Our Ref: 239971  
Council Ref: DA/2022/00538

**RE: DA/2022/00538 - COMMERCIAL PREMISES & SHOP TOP HOUSING DEVELOPMENT  
LOT 1 DP 1166015 - 643 HUNTER STREET, NEWCASTLE WEST**

Please accept this submission as our formal response to the further comments provided by City of Newcastle's internal referral responses to DA2022/00538 via email on the 14<sup>th</sup> September 2022.

**DRAWING TITLE**  
**SITE PERMEABILITY CALCULATIONS**  
**PROJECT No.** 7330-01      **DRAWING No.** 006      **AMDT** 1

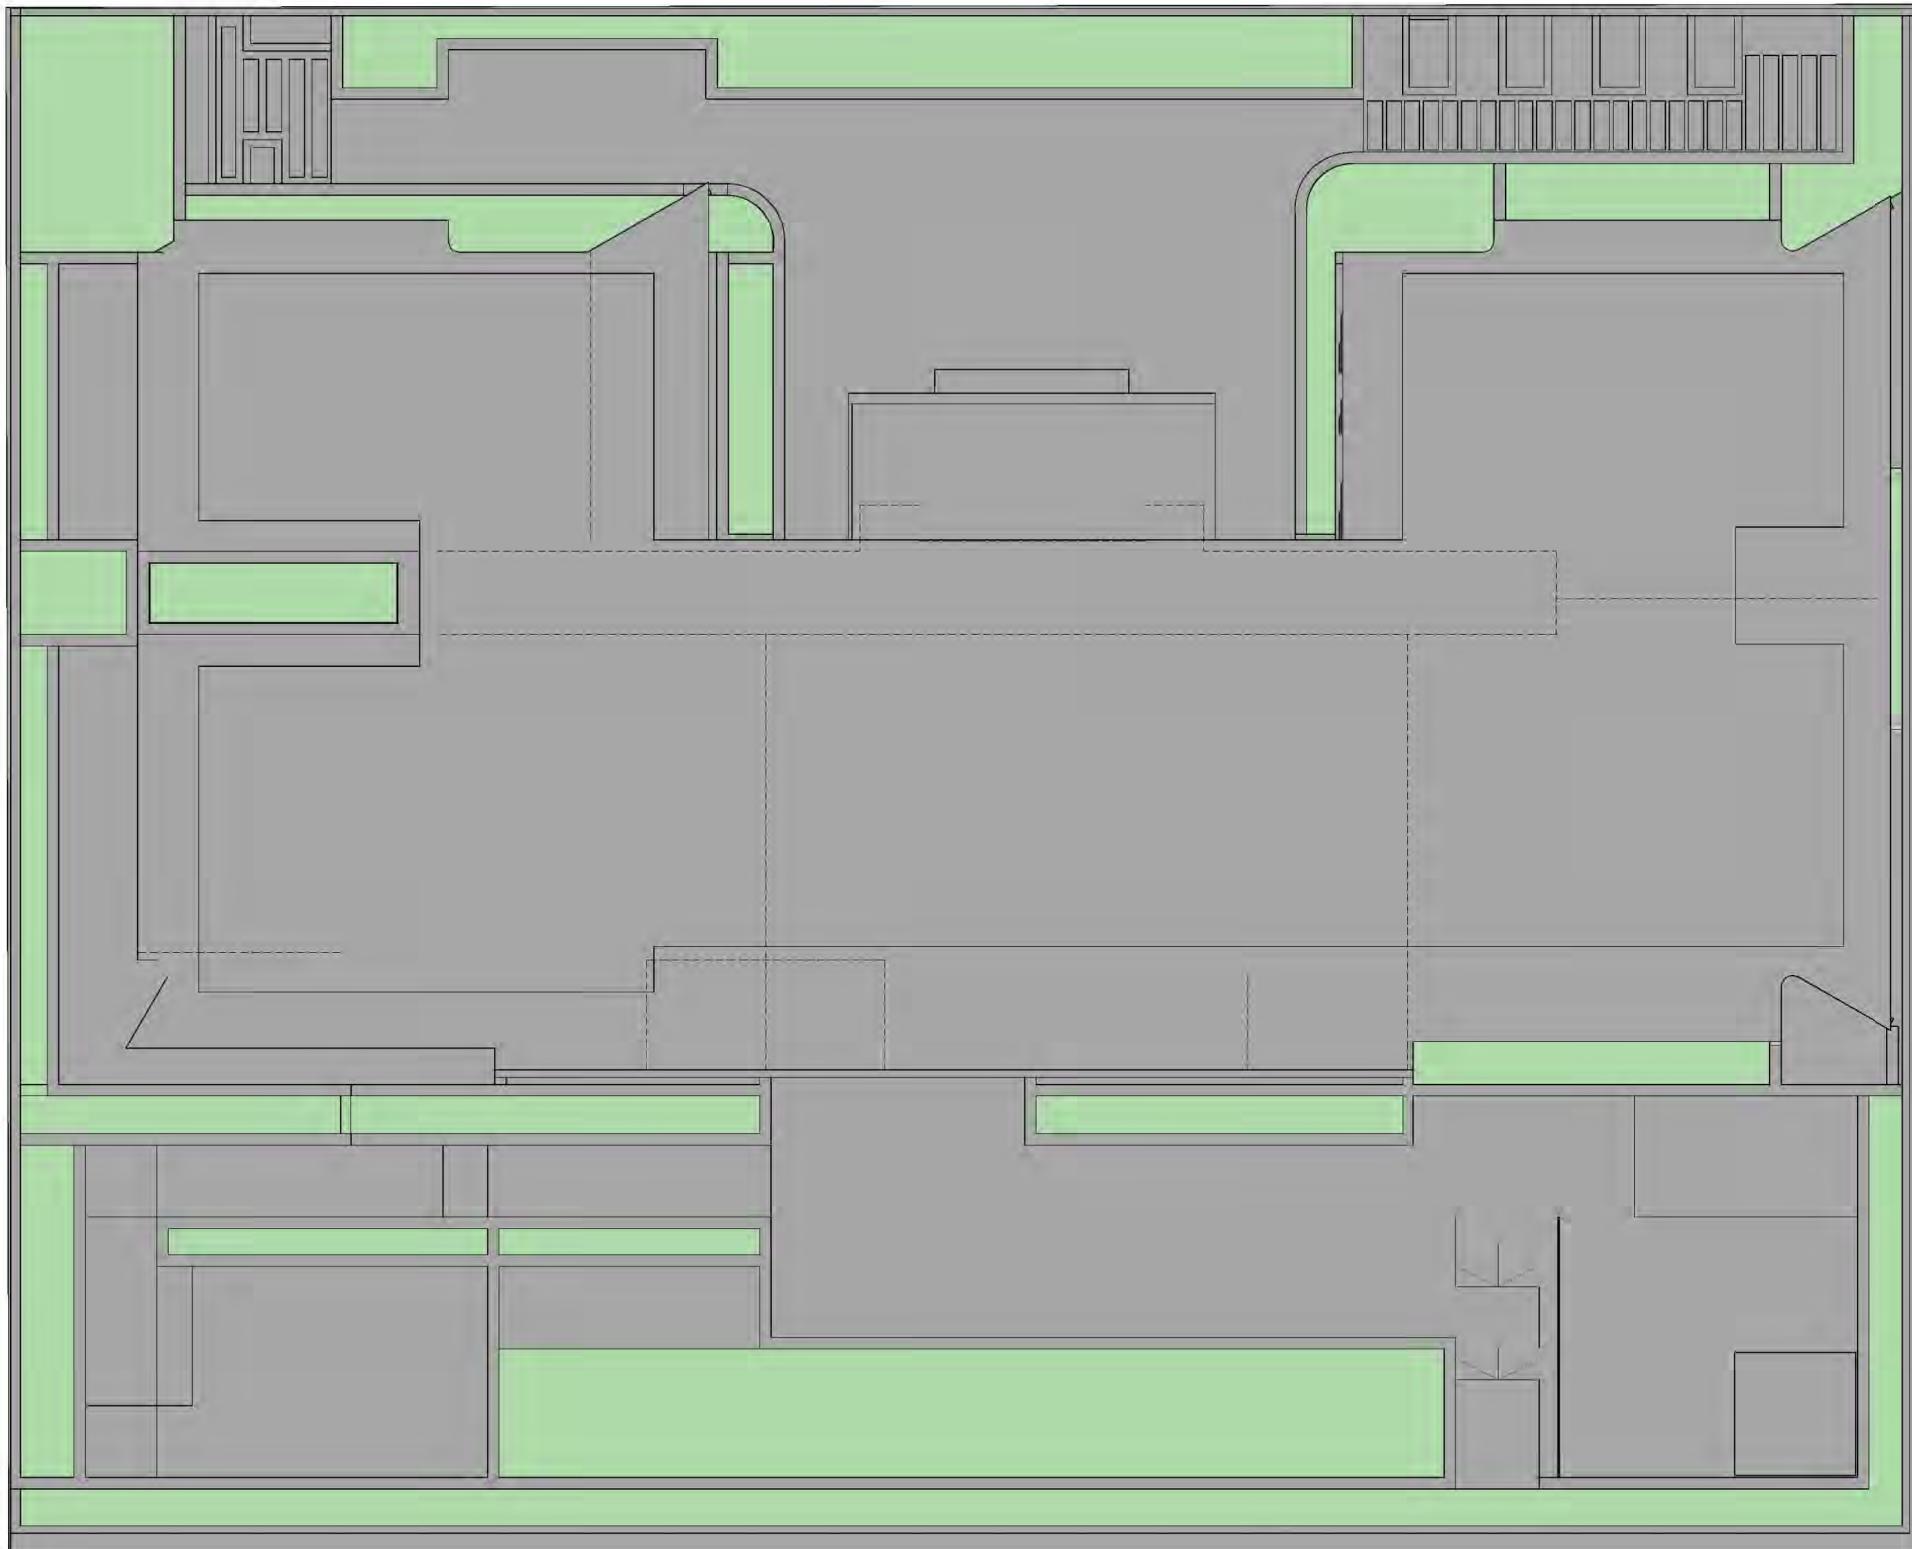
<p>To account for the retention benefit of green roofs during minor storm events, NDCP controls can be relaxed to require the on-site storage of stormwater for only 12mm of rainfall over all green roof areas, and 25mm (for 100% impervious development) over all other impervious areas. The Applicant is requested to provide a catchment map of the development identifying all roof, unroofed impervious and green roof areas. Typical cross-sections are to be provided for the proposed green roof areas. Additional on-site storage will likely be required in the form of a retention tank.</p>	<p>Green roof retentions have been considered. A catchment map has been provided (Refer to sheet 7330-01-006) as well as Typical cross section details (Refer to sheet 7330-01-007).</p>

**DRAWING TITLE**  
**WASTE MANAGEMENT PLAN**  
PROJECT No. 7330-01 DRAWING No. 020 AMDT 2

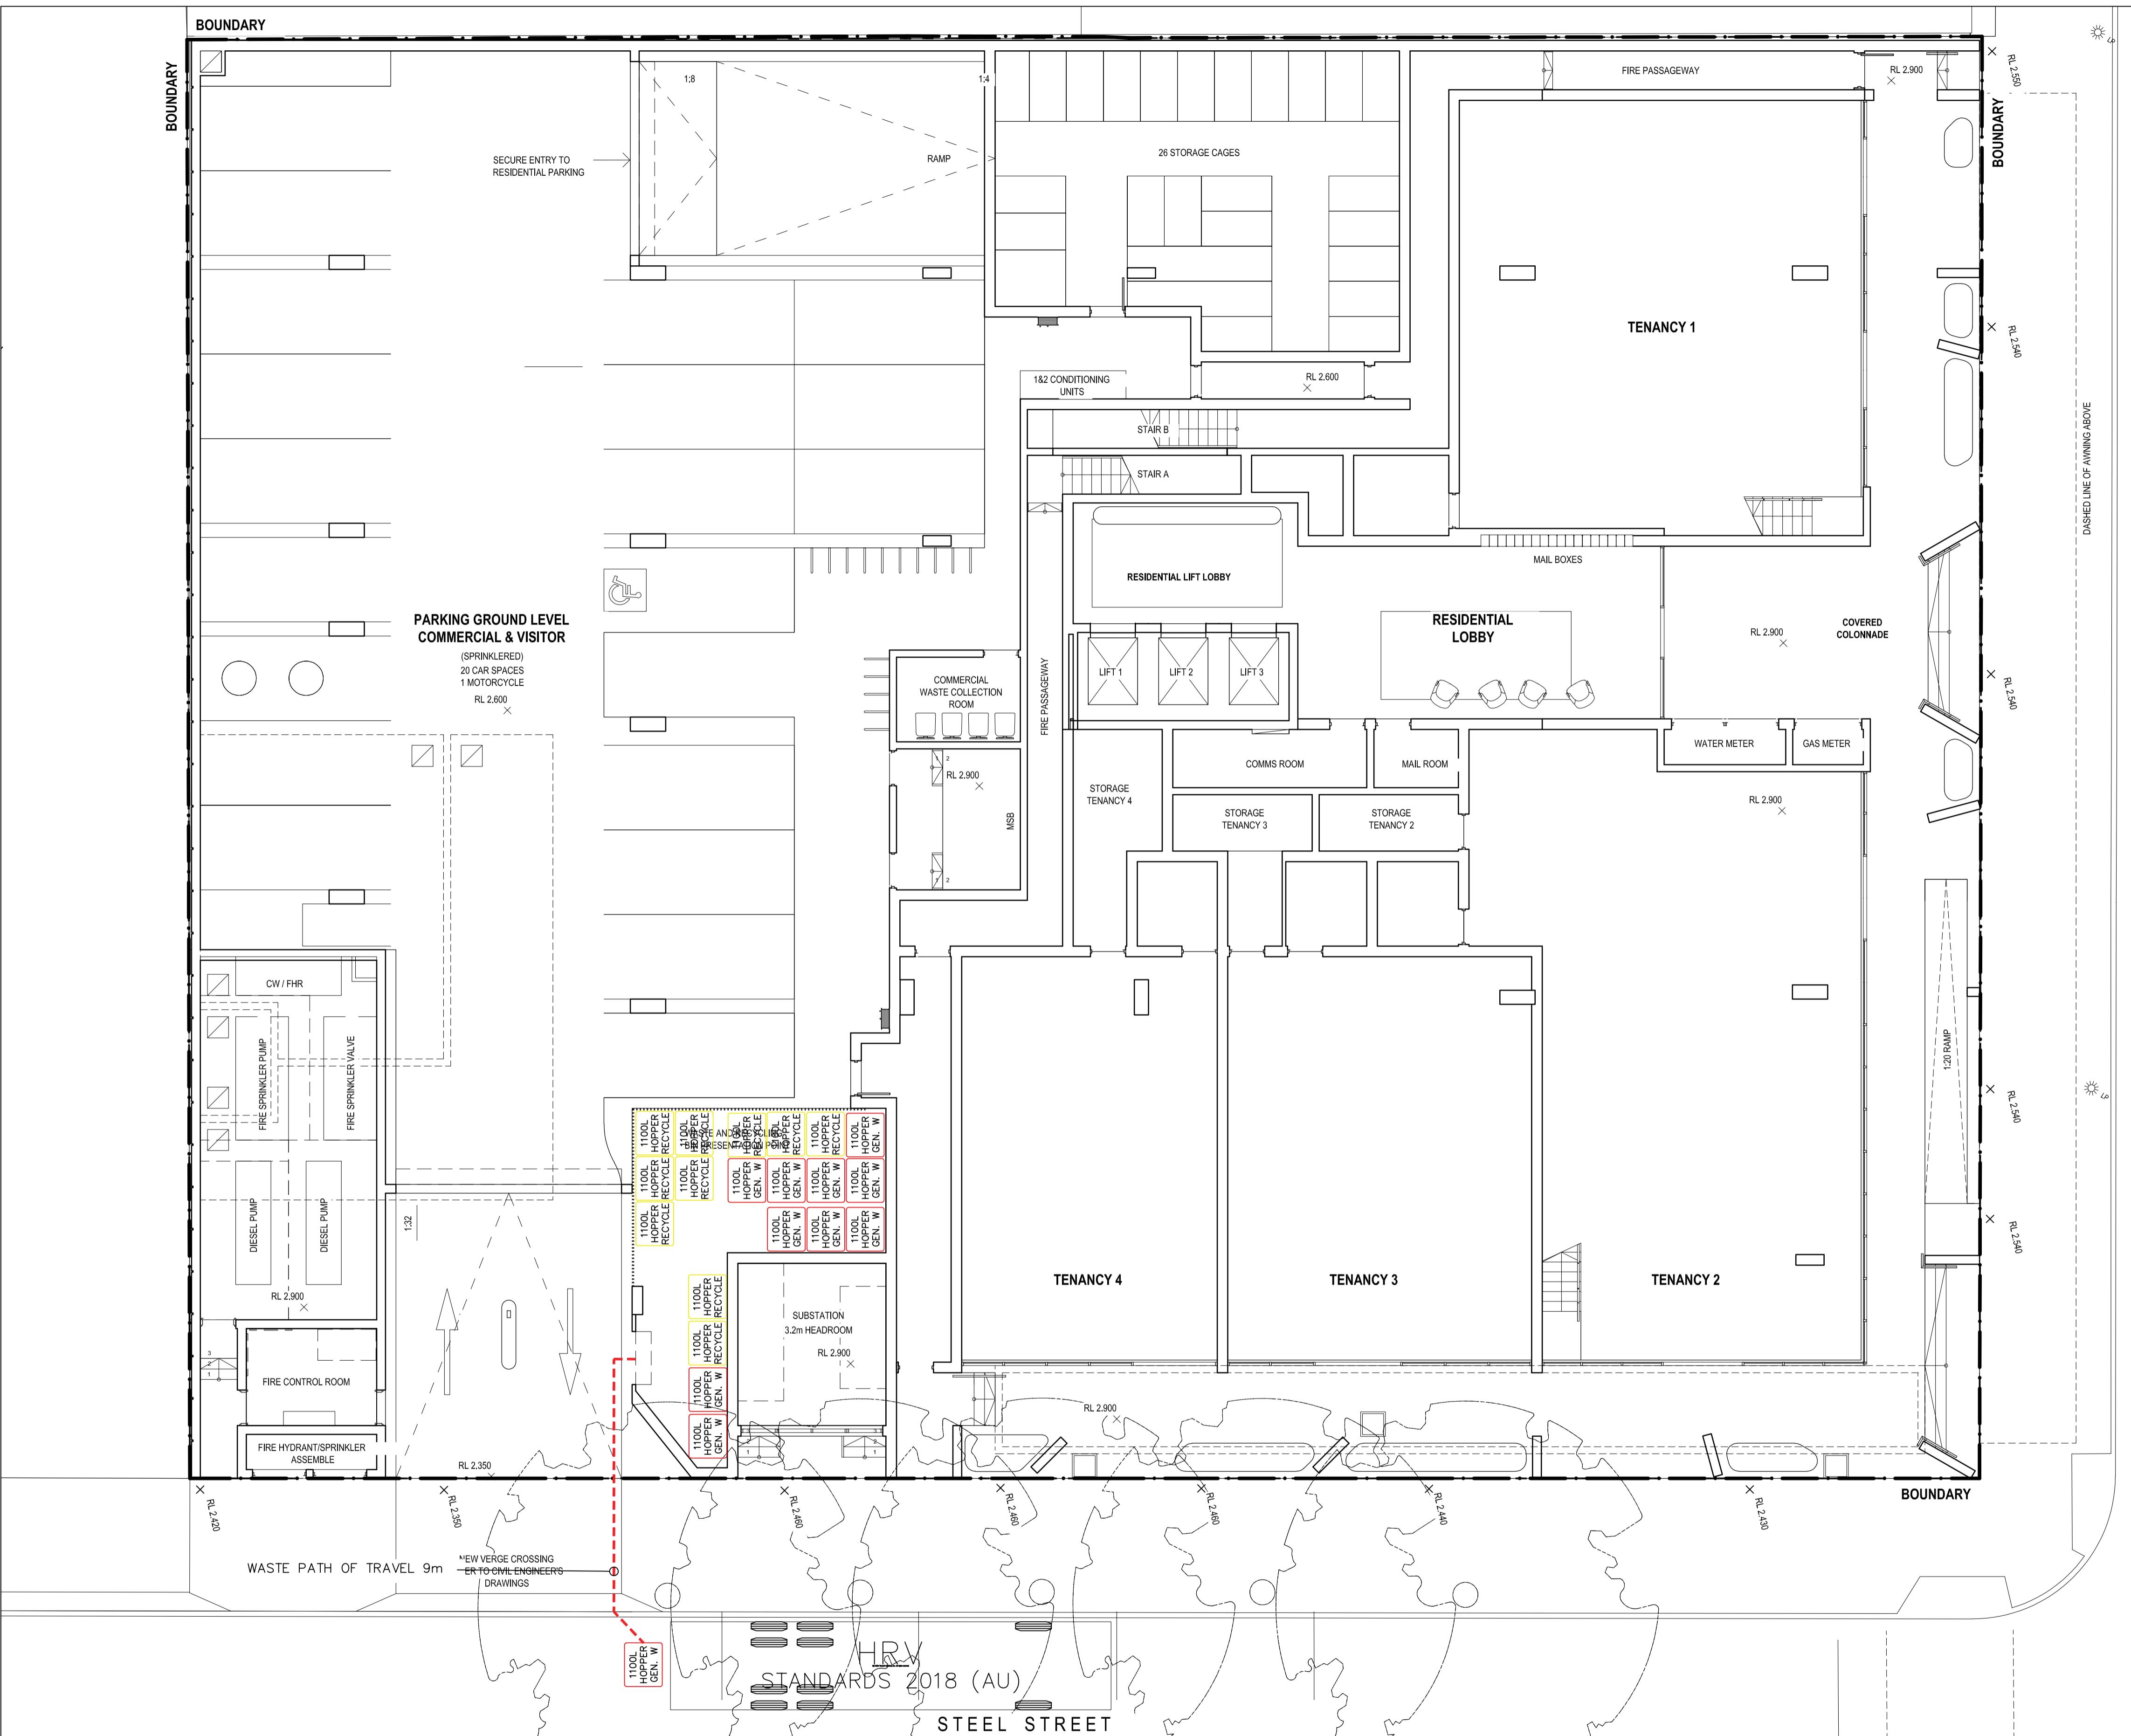
Waste collection rates have been updated as shown on the amended Concept Civil Plans provided within **Appendix A**.

As nominated in Council response to waste collection, collection for residents is to occur individually on the designated parking level of their unit, the designated building manager will facilitate the moving of waste from parking levels as required during the week. As shown on the amended waste management plans provided within **Appendix A** all of the required bins can fit within the ground floor waste room on collection day. As part of the management of the bins, these will be rotated by the building manager for collection. Waste collection will occur at the nominated waste collection point within close proximity to the kerb side frontage.

PROJECT No.	7330-01	DRAWING No.	040	AMDT	1
-------------	---------	-------------	-----	------	---

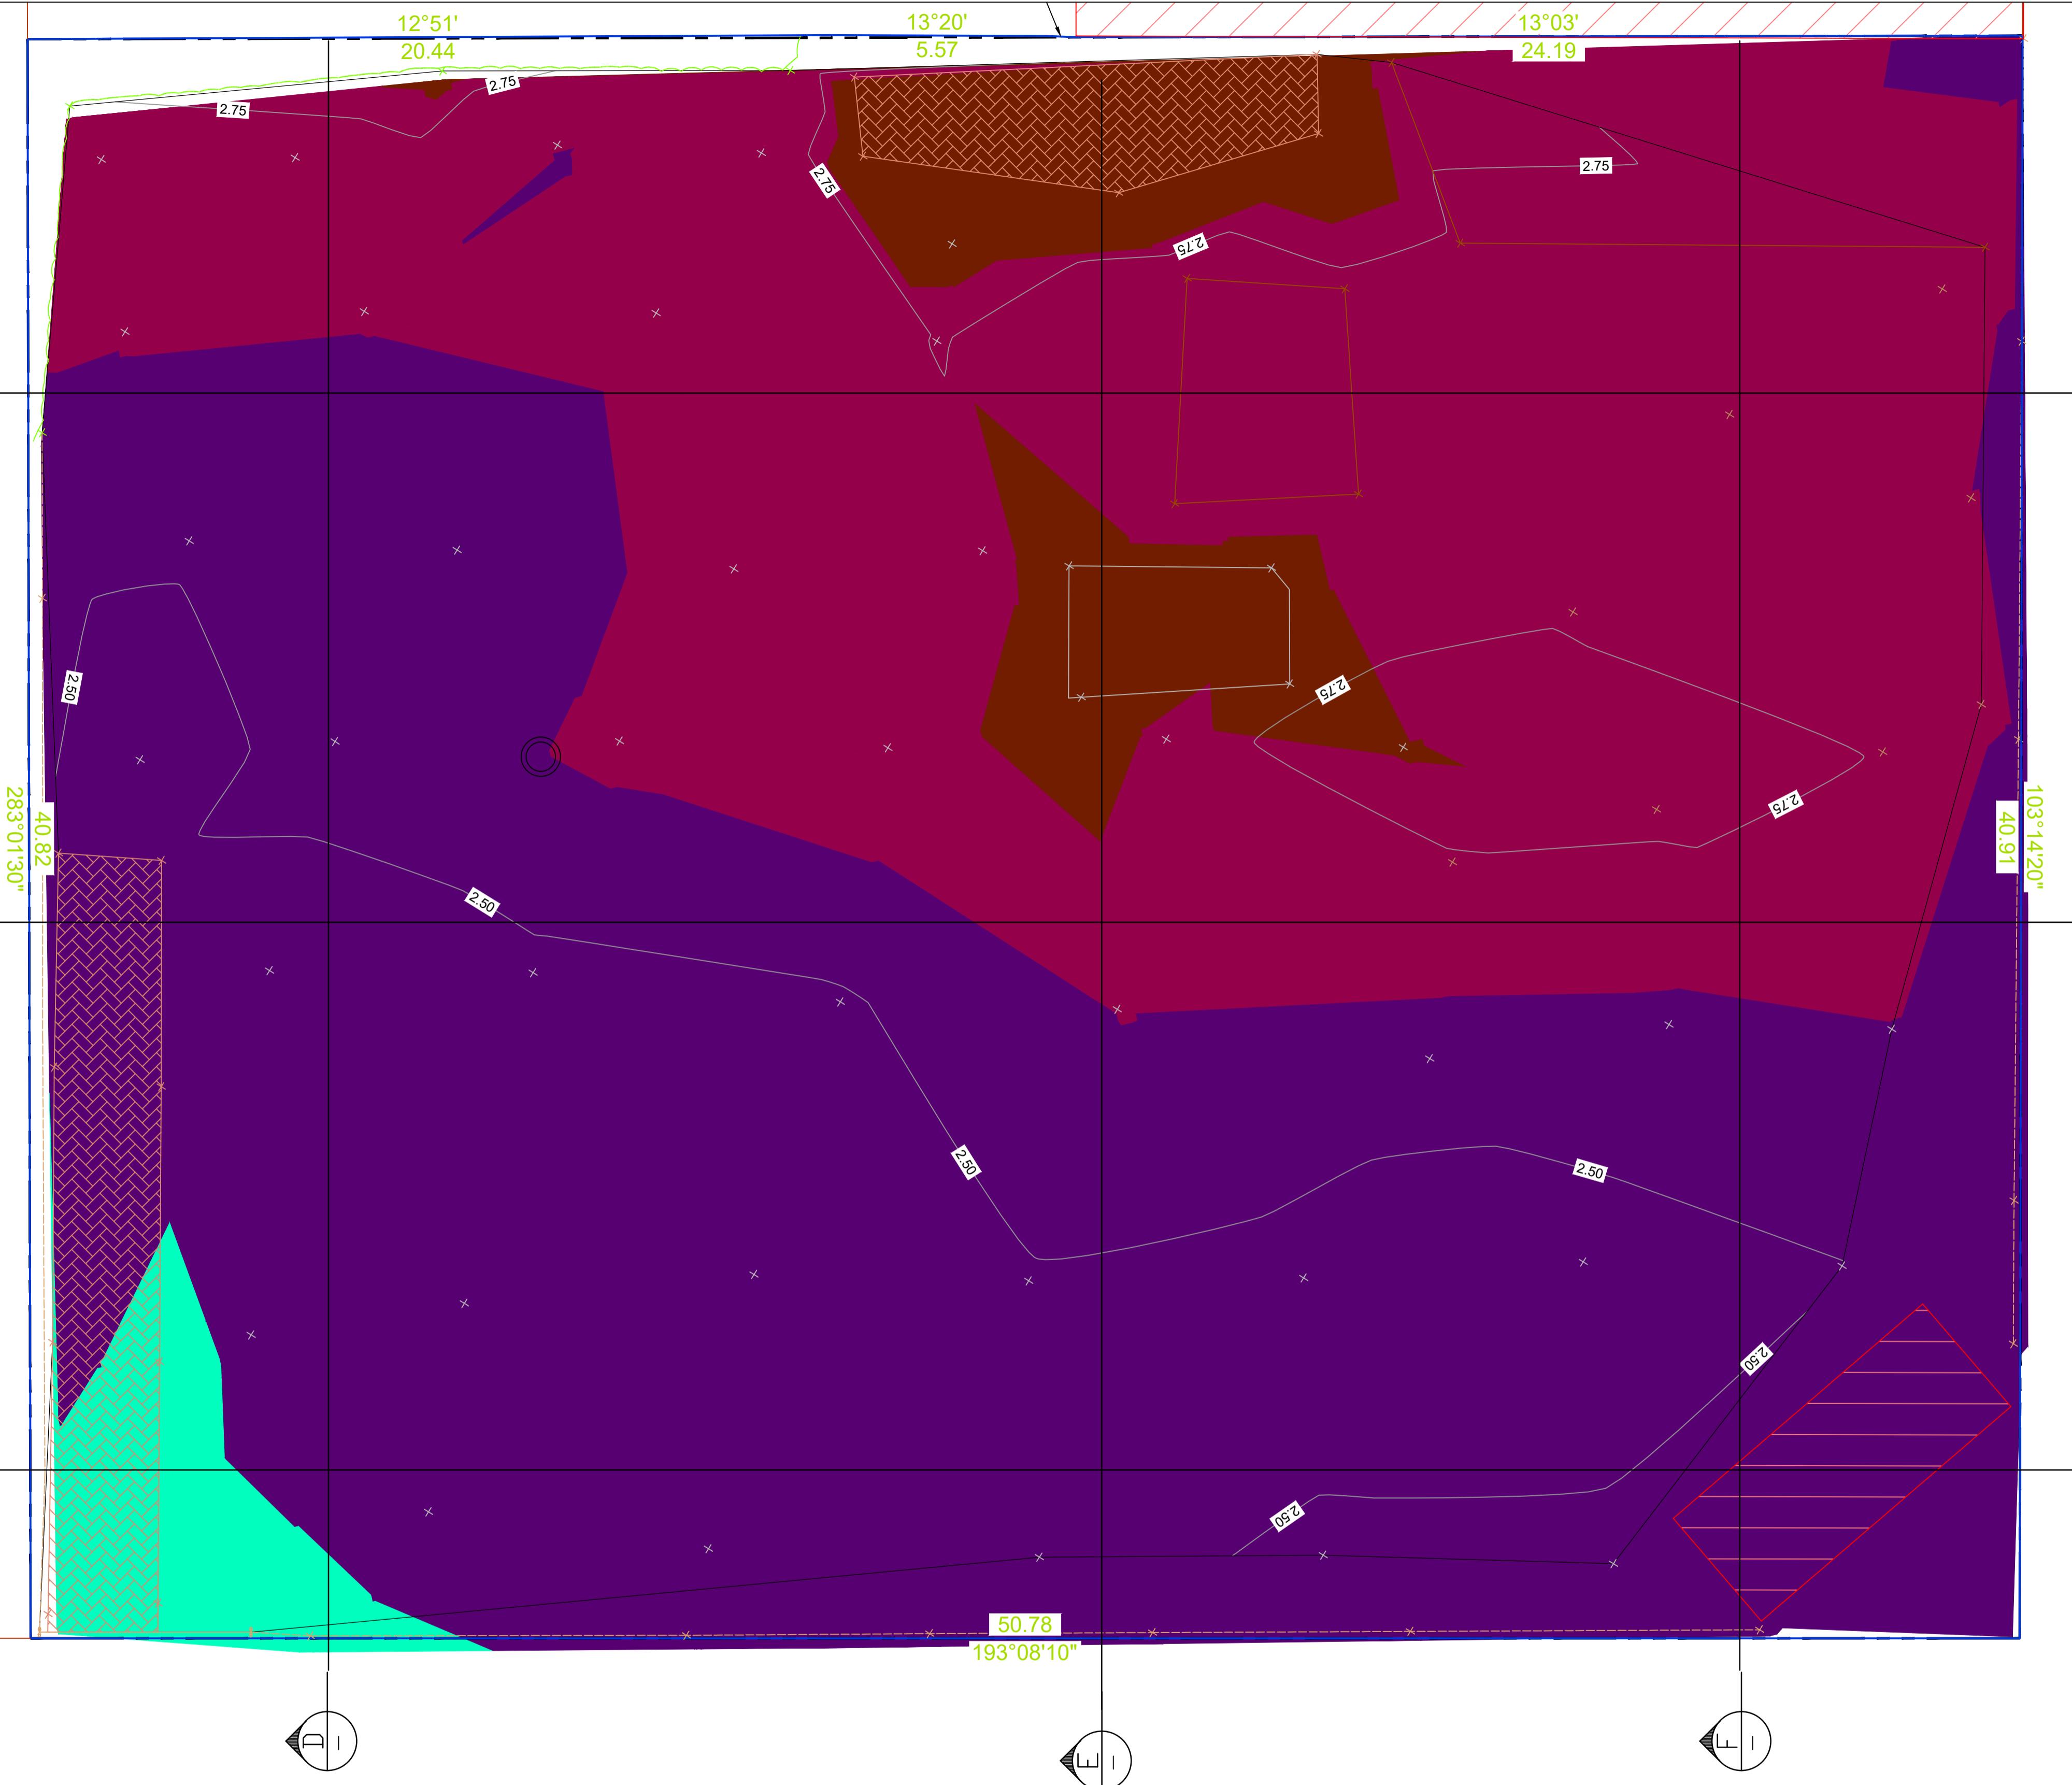
2.2 Flood Storage – Council Comment	Response
The development does not address NDCP requirements for flood storage preservation. The submitted SEE acknowledges "the subject site is identified as a Flood Control Lot" but erroneously states that "the site is not affected by a floodway or a flood storage area."	As a requirement of Section 4.01 of the Newcastle Development Control Plan (NDCP), any development on the site shall not fill more than 20% of the allotment area. Cut and fill plans have been submitted showing that the site will not reduce the total storage available in the PMF event by more than 20%.
Calculations are to be included for natural and post-development flood storage volumes within the site during the Probable Maximum Flood event. Displacement exceeding 20% of the natural storage volume over the site may be addressed through the provision of compensatory on-site storage.	Calculations have been provided on the PMF Storage drawings (Refer to 7330-01-040/041).
